**CANADIAN ARCTIC RESOURCES COMMITTEE FINAL REMARKS:  
CRITIQUE OF THE PROPONENT'S CUMULATIVE EFFECTS ASSESSMENT  
(CEA) FOR THE MACKENZIE GAS PROJECT (MGP)**

These final remarks focus on two central points: the failure of the EIS to establish a need for the project as applied for and the failure of the EIS to adequately take into account the assessment of cumulative impacts as mandated by the *Terms of Reference*, and which according to Annex 2 to the Schedule of the *Agreement for an Environmental Impact Review of the Mackenzie Gas Project* are factors to be considered during the review.

Hypothetical Scenario

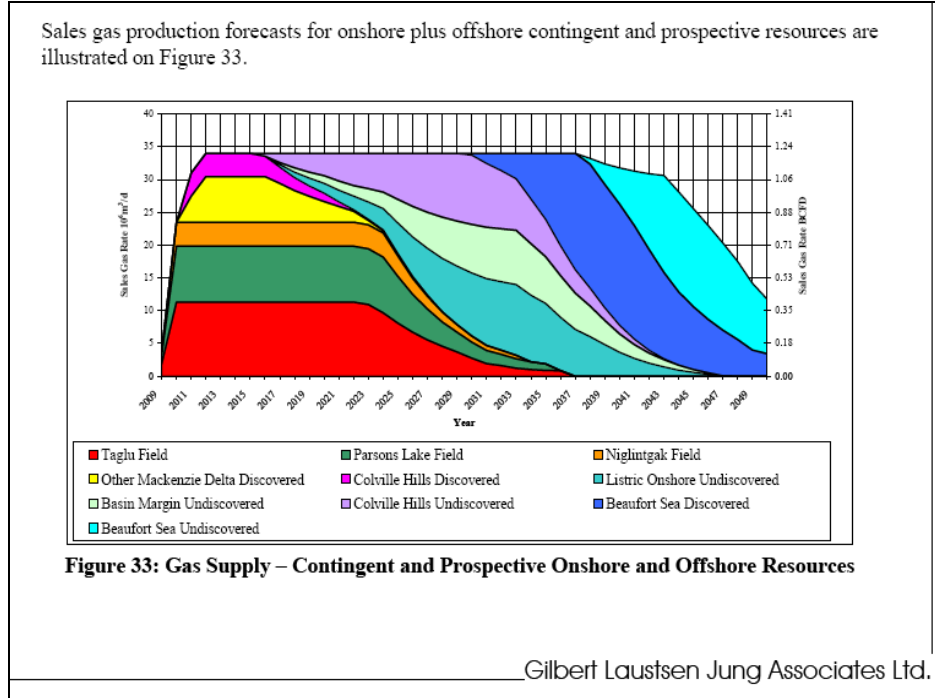
4. Despite the fact that the Proponent is applying for 1.2 BCFD of pipeline capacity, which is approximately 0.4 BCFD over and above its stated need, and despite the fact that the Proponent has issued an "Open Season Expression of Interest", the CEA considers all additional gas field development to be "hypothetical":

*The following hypothetical natural gas development scenario and associated expansion of the Mackenzie Valley pipeline was prepared for illustration only and is highly uncertain.* [emphasis added] It represents one potential scenario that might happen. Irrespective of the extent of future natural gas development in any of the regions used in this scenario, i.e. Mackenzie Delta, Colville Hills, or Beaufort Sea, any new activity would require its own regulatory approvals and cumulative effects assessment.
